# Request for Quotation

RFQ NUMBER  
 GSD106447

LINE	QUANTITY	UOP	CAT NO	ITEM NUMBER	UNIT PRICE	AMOUNT
ADDENDUM NO. 2						
THIS ADDENDUM IS ISSUED TO ADD THE FOLLOWING:						
1.) GSD106447 ADDENDUM NO. 2 DOCUMENTS, 4 PAGES.						
2.) GSD106447 QUESTIONS AND ANSWERS, 13 PAGES.						
3.) 15 CONSTRUCTION DRAWINGS.						
***** END OF ADDENDUM NO. 2 *****						
0001	1	LS		968-20		
CONSTRUCTION OF NEW OFFICE BUILDING, LOGAN, WV						
***** THIS IS THE END OF RFQ GSD106447 ***** TOTAL:

The following items revise the Bidding Document Drawings and Specifications dated June 10, 2010. Acknowledge receipt of this Addendum at the appropriate location indicated on the bid Proposal Form; failure to do so may be deemed a lack of bid responsiveness and can be cause for rejection of the Bid.

DATE DWG. REF.  
 07-09-10 A2.01

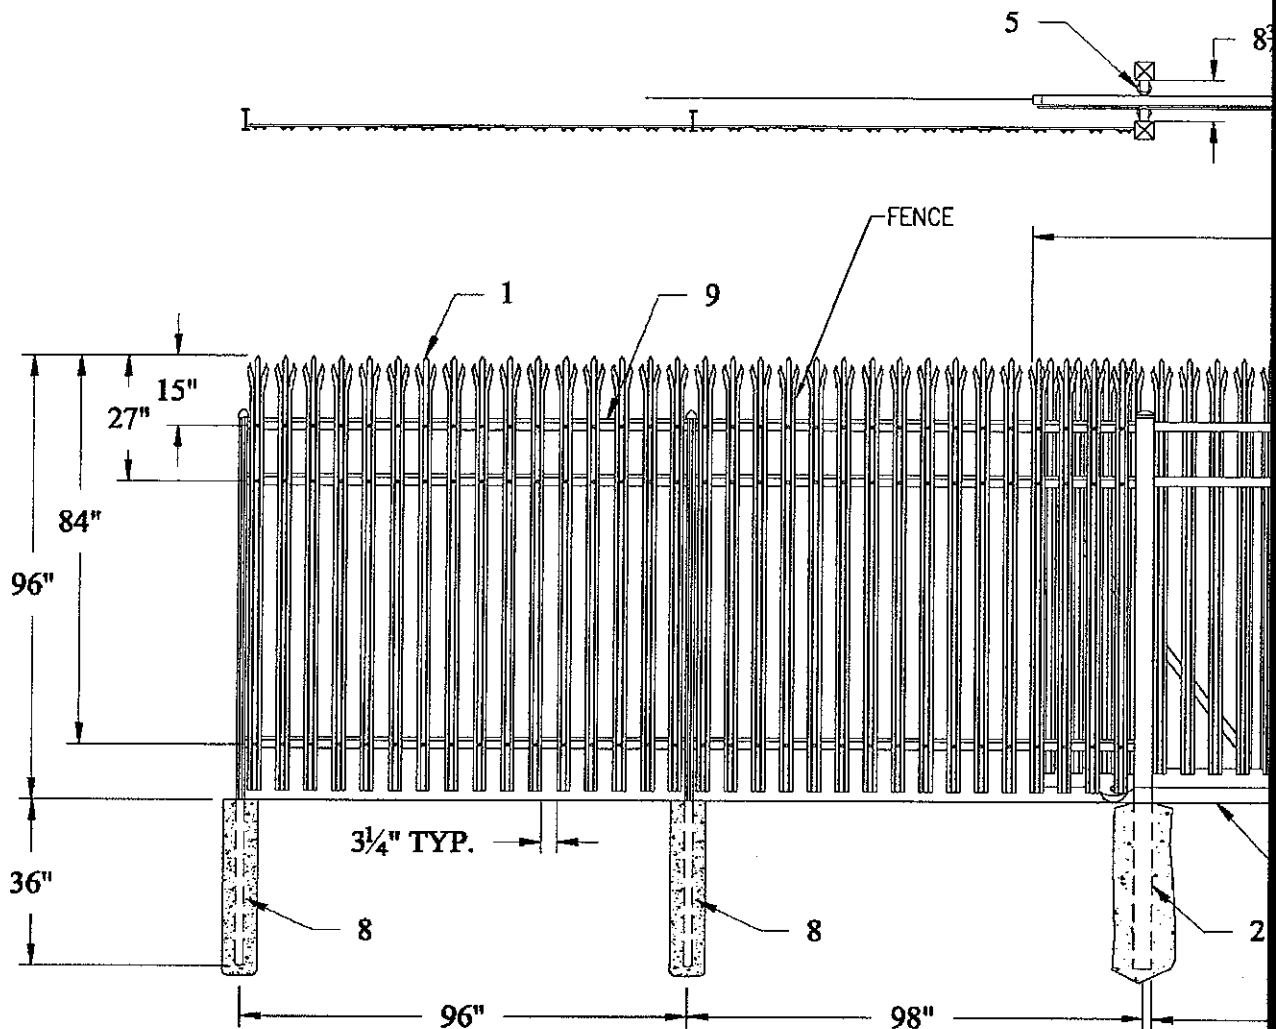
**Answer: Stainless steel not required.**
11. Please furnish the dimensions marked with an asterisk on the attached partial Drawing 1/A2.01.  
**Answer: See Sketch # AD-1-A-1**

REVIEWED	
A ___	FP ___ M ___
C ___	P ___ E ___
S ___	
DATE	DWG. REF.
6/21/2010	C1.07
DRAWING No.	
AD-1C-1

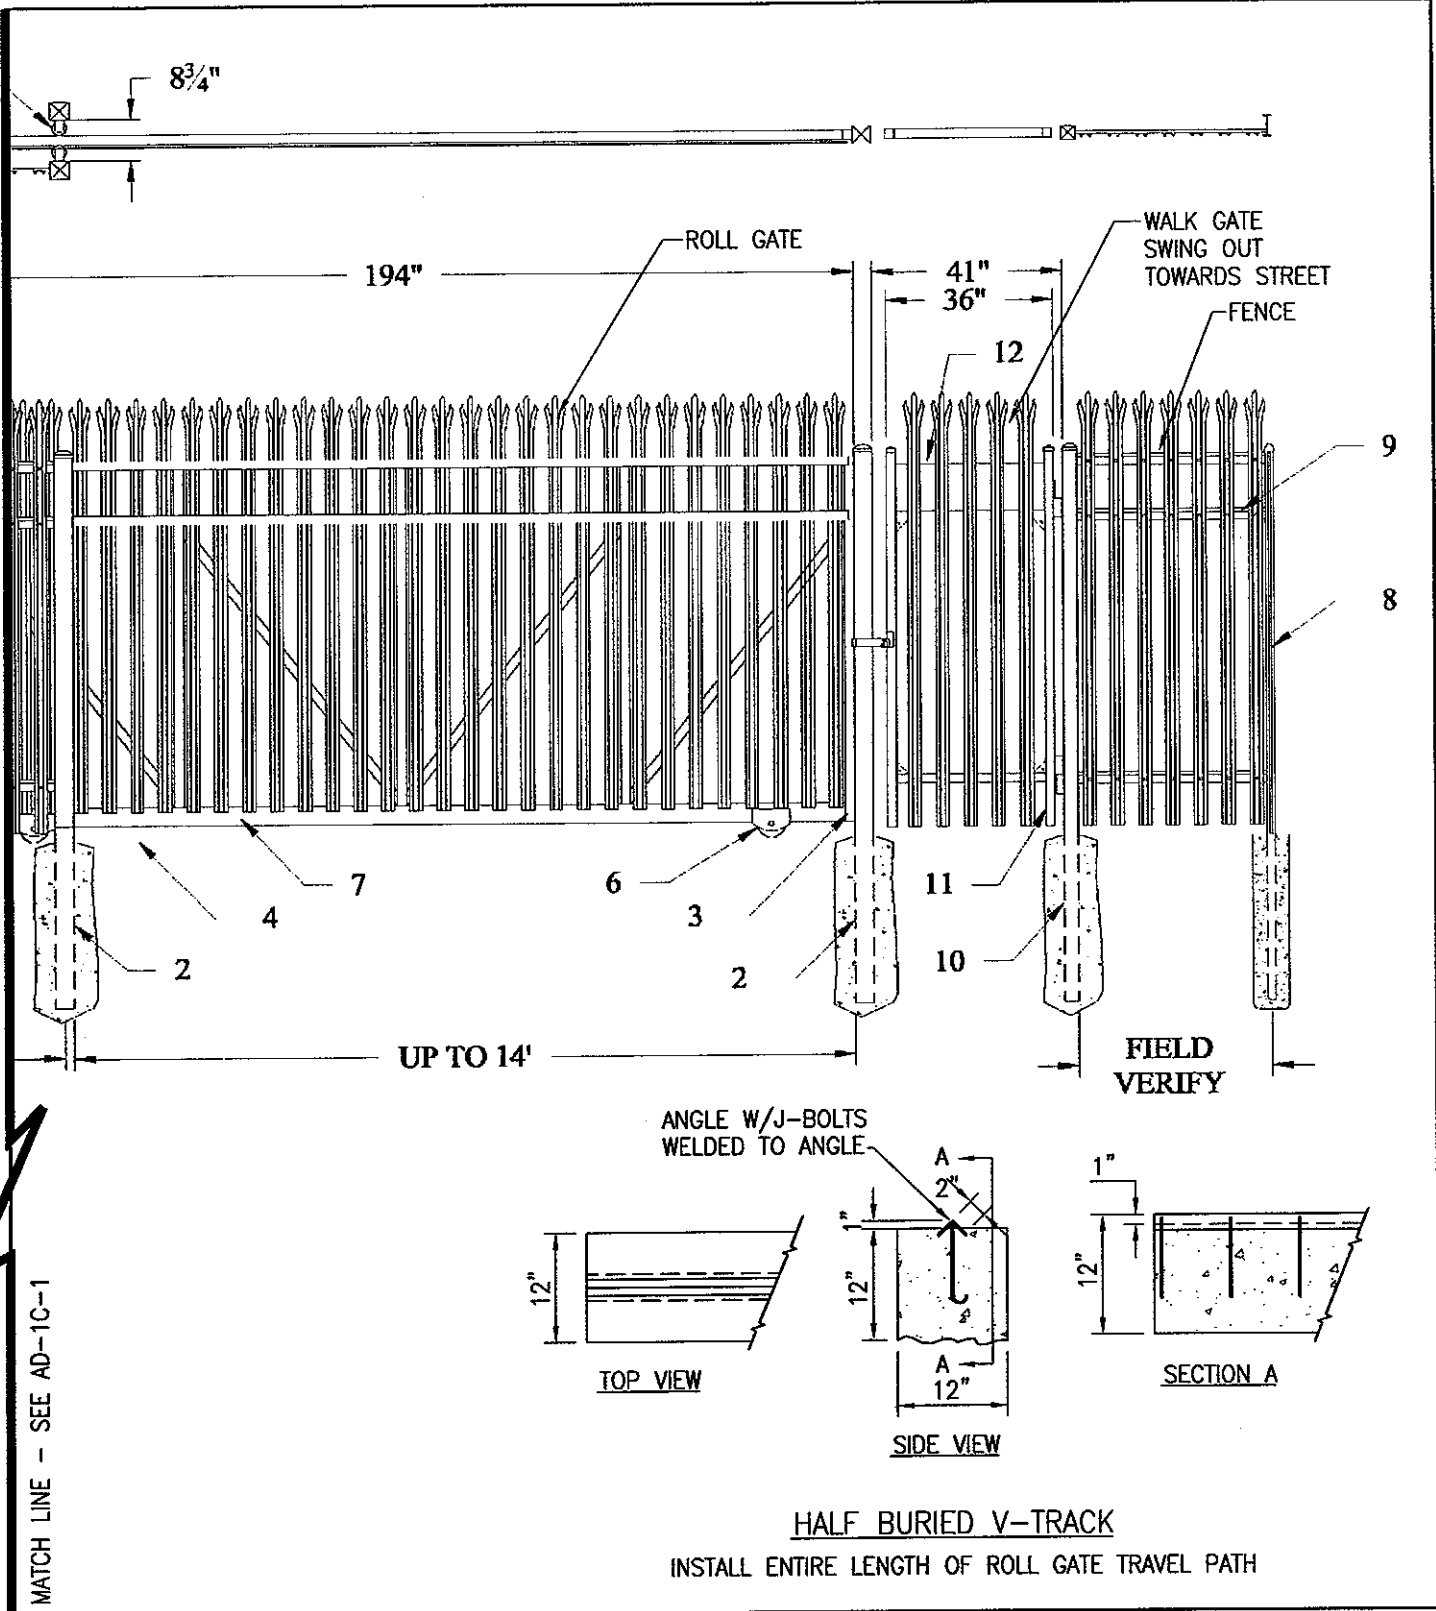
ABOVE IS THE SOUTH ELEVATION.  
 THE NORTH ELEVATION WILL NOT HAVE THE WALK GATE. FIELD VERIFY DIMENSIONS. WHEN ORDERING THE MATERIALS, STATE THAT THIS IS A LEED PROJECT.

DATE	DWG. REF.
7/09/2010	C1.05
DRAWING No. AD-1C-3

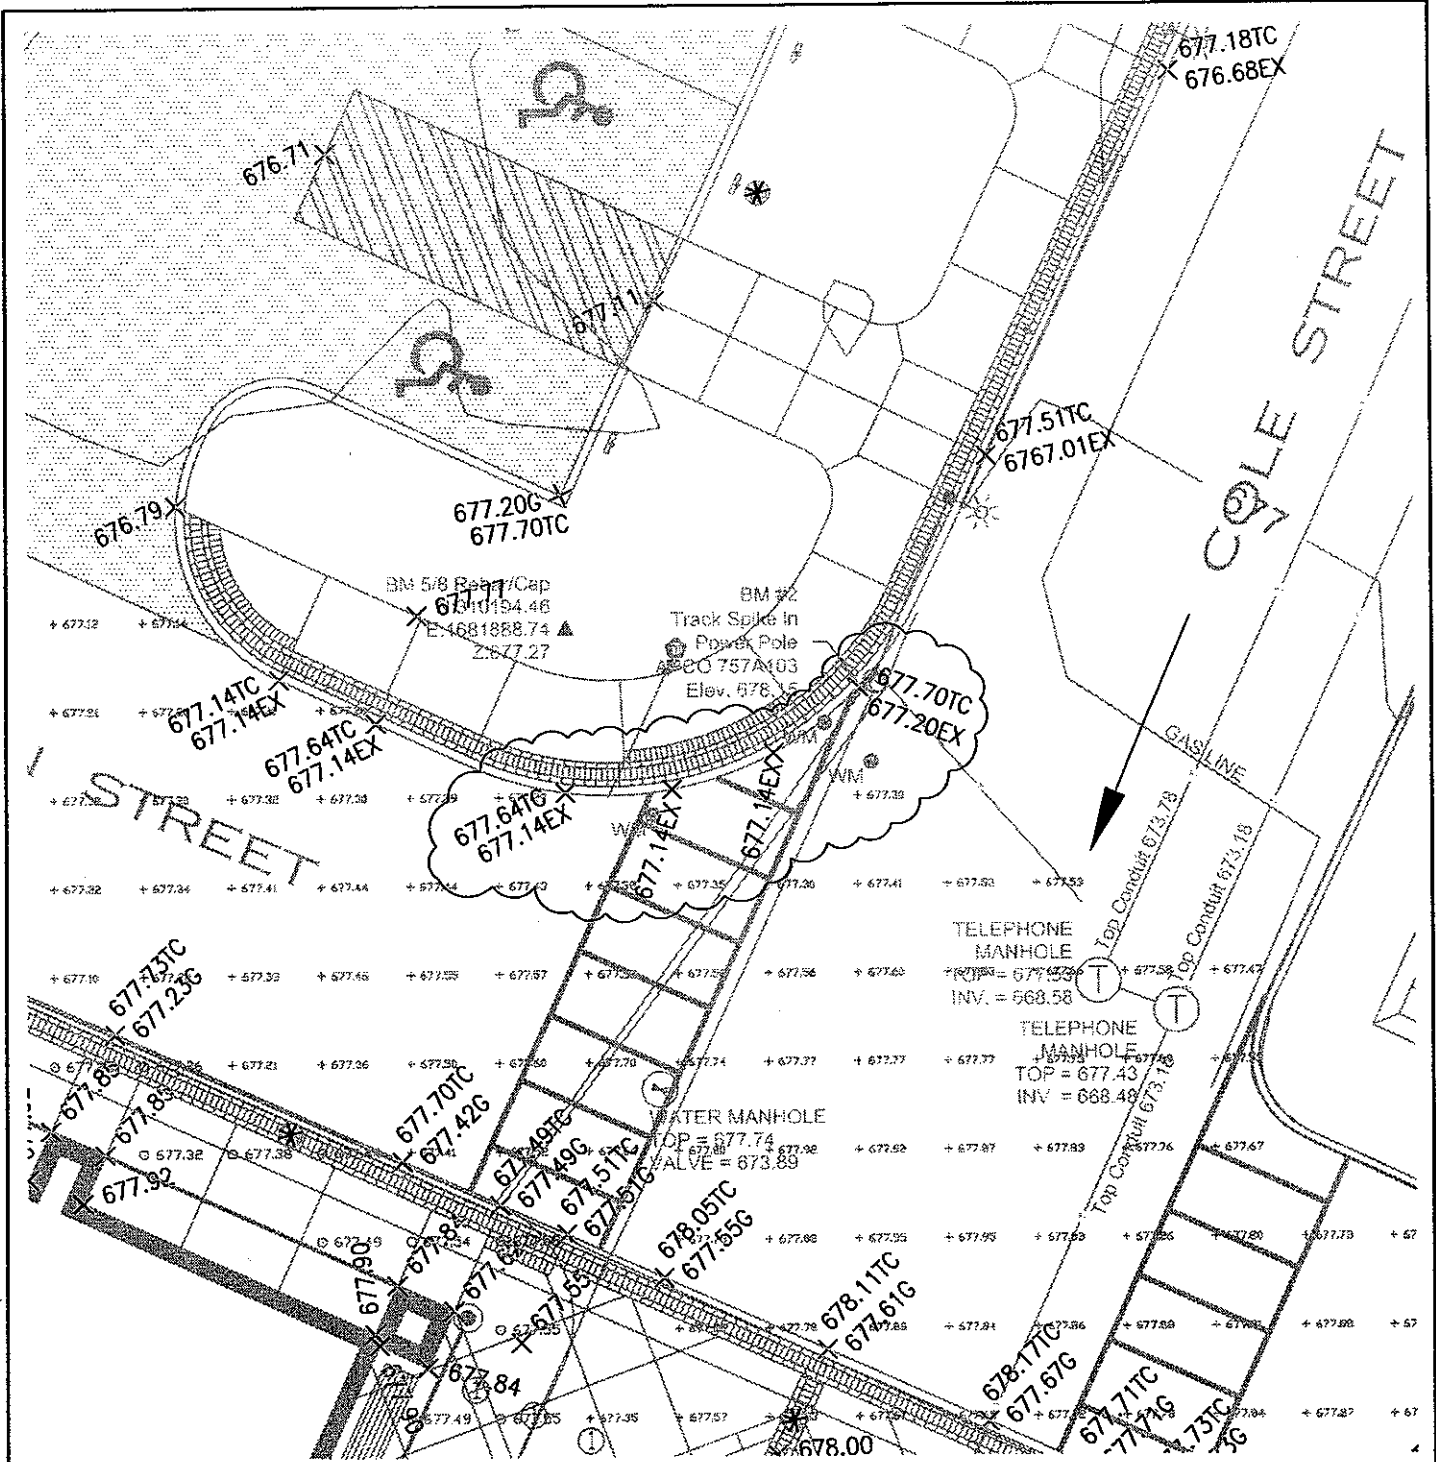
**Answer: Shutoff valve added to C1.05.**
37. "H" drawings do not indicate shutoff valves on chilled or heating water risers or mains. Will they be required? Where?

DRAWING No.  
AD-1C-5

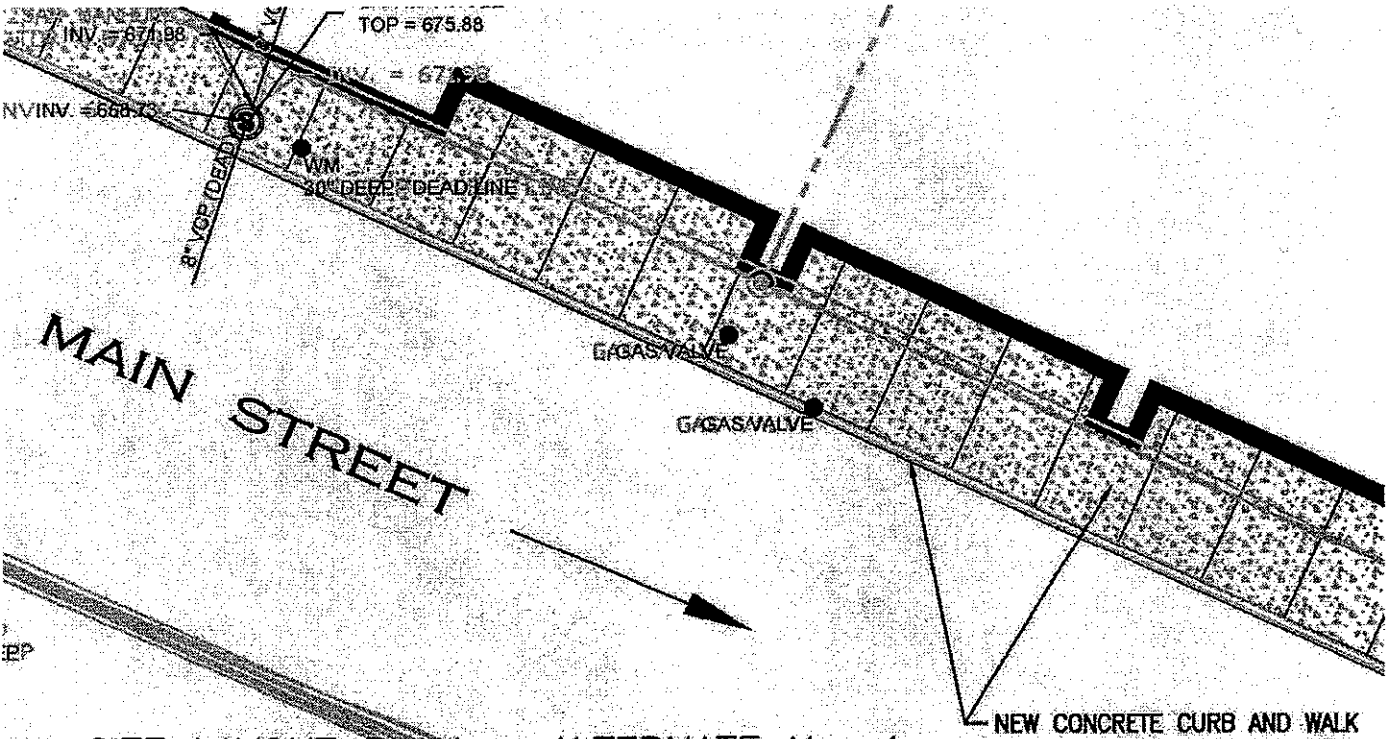
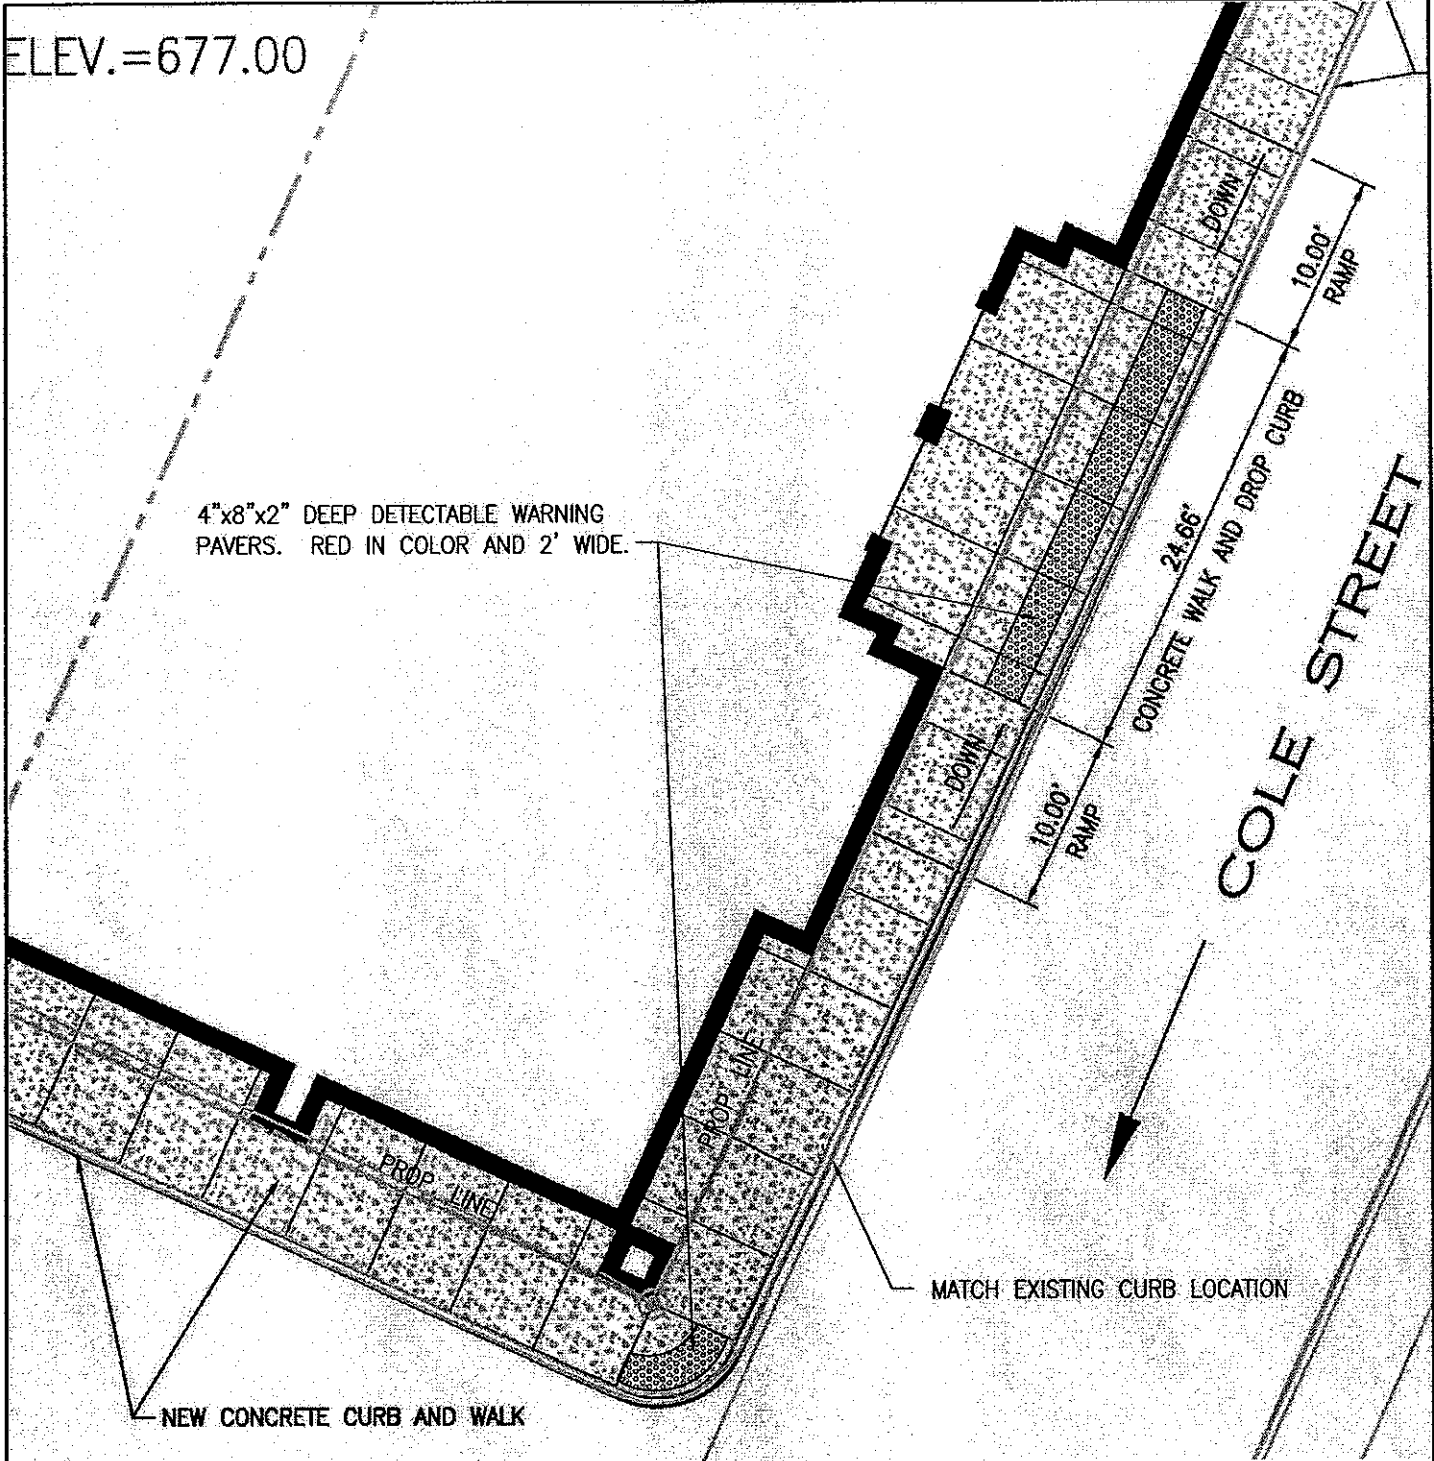
20. Alternate deduct – The description of work for the alternate deduct does not provide specific instructions on what work will be taken out, what work will be installed in place of the removed work and the exact location of the work effected. Please provide an itemized description of all work to be removed. All areas of work that will fall under this alternate deduct category and work that will be installed in lieu of the original work. At the moment, this alternate could be interpreted several different ways.

**Answer: See attach Sketches #AD-1C-5, AD-1C-6, AD-1C-7, AD-1C-8, AD-1C-9, AD-1C-12, and AD-1C-13.**
21. Please provide a detail/dimension for the perimeter insulation detail. Additionally, does the perimeter insulation install vertically @ the perimeter grade beam? One detail shows this with no dimension and several others show it to the top of the grade beam?
